Re Indian Point Unit No. 3
Docket No. 50-286

In response to Item 1 of your January 21, 1976 letter, valves 842 and 843 in the mini-flow return line from the discharge of the safety injection pumps to the re-fueling water storage tank will be de-energized in the open position whenever the reactor coolant system TAVG is greater than 350°F. This condition is indicated in paragraph 3.3.A.3.j of the proposed full power Technical Specifications transmitted to you by letter dated January 29, 1976.

ATTACHMENT A

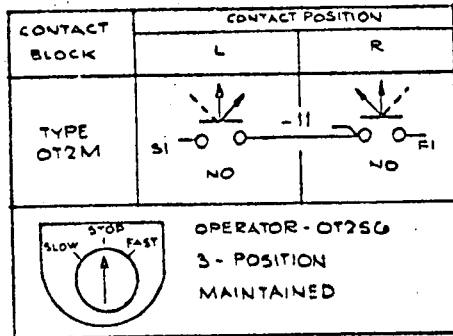
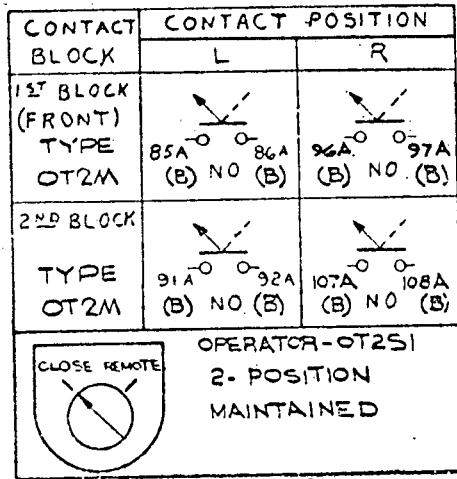
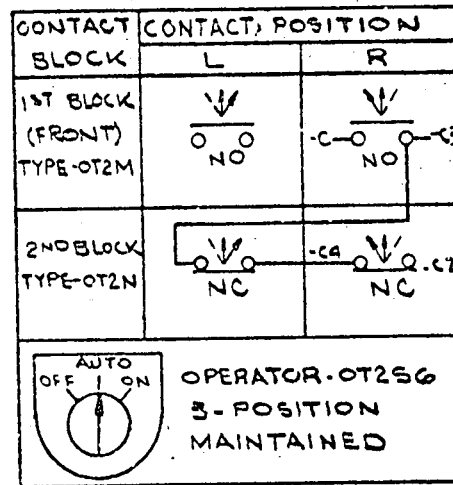
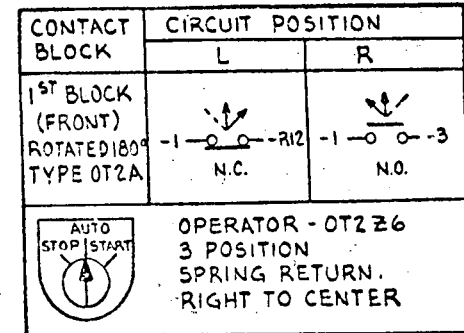
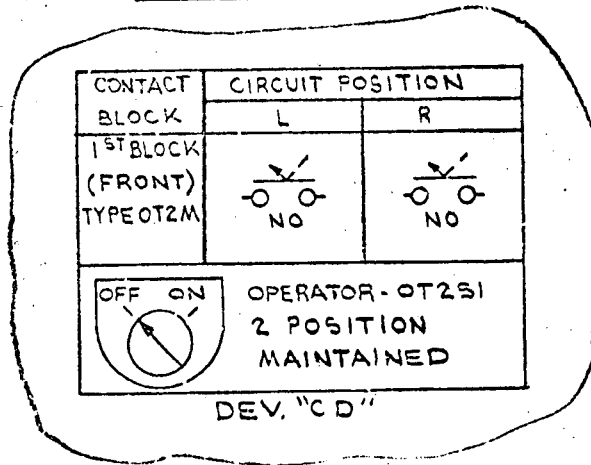
At least one of these two valves must be closed during the recirculation mode of a loss of coolant accident to prevent radioactive water from entering the re-fueling water storage tank. Therefore, each valve will be provided with its own power "ON-OFF" switch to allow restoration of power from the control room. During the changeover from injection to recirculation transferring each "TWO POSITION-MAINTAINED" switch to the "ON" position will restore power to the control circuit and, thus, permit the existing valve control switches in the control room to operate the valves. A status light on each "ON-OFF" switch module will indicate when the control circuit is operable.

A listing of those electrical schematics affected by these changes is delineated in Attachment A. Forwarded herewith are seven (7) copies of finalized versions of those schematics listed in Attachment A.

Westinghouse Electric Corporation	
NUCLEAR ENERGY SYSTEMS, PITTSBURGH, PA., U.S.A.	
TITLE: CONSOLIDATED EDISON CO.	
INDIAN POINT STATION-UNIT NO. 3	
S.I. VALVES POSITION LIGHT	
SCALE	500B971
DIMENSIONS IN INCHES	SHEET 172
DO NOT SCALE	SUB 1

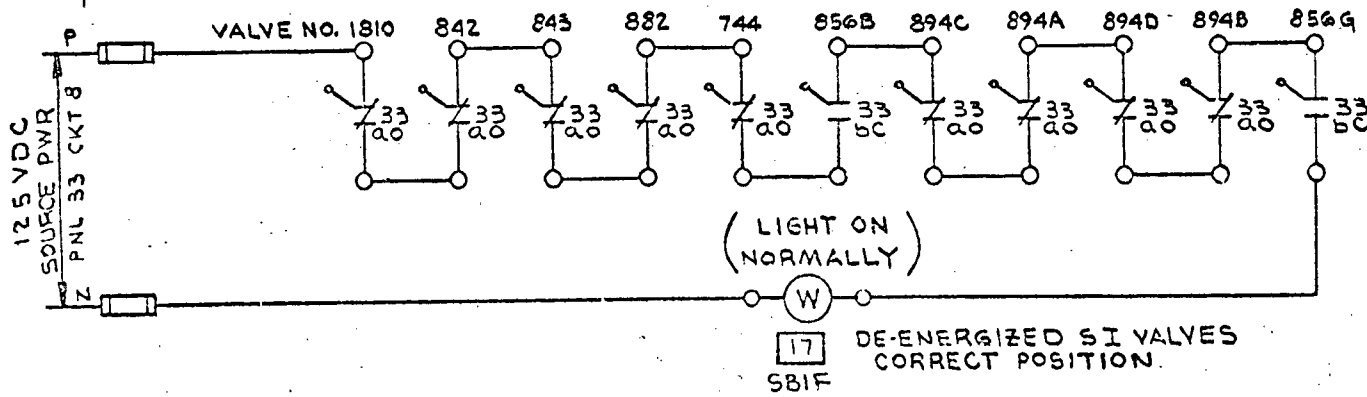
Finally, redundant position indication will be provided in the control room in accordance with NRC Branch Technical Position EICSB 18 by supplementing the existing indication systems with an independent status light system. The new status light system consists of

separate limit switches mounted on each valve stem and cables routed in dedicated conduit separate from the existing raceway system. Within the control panel the power supply (circuit 8 on d.c. power panel 33) and the alarm chain will be routed in flexible ("sealtite") conduit into a spare module where the status light will be mounted.
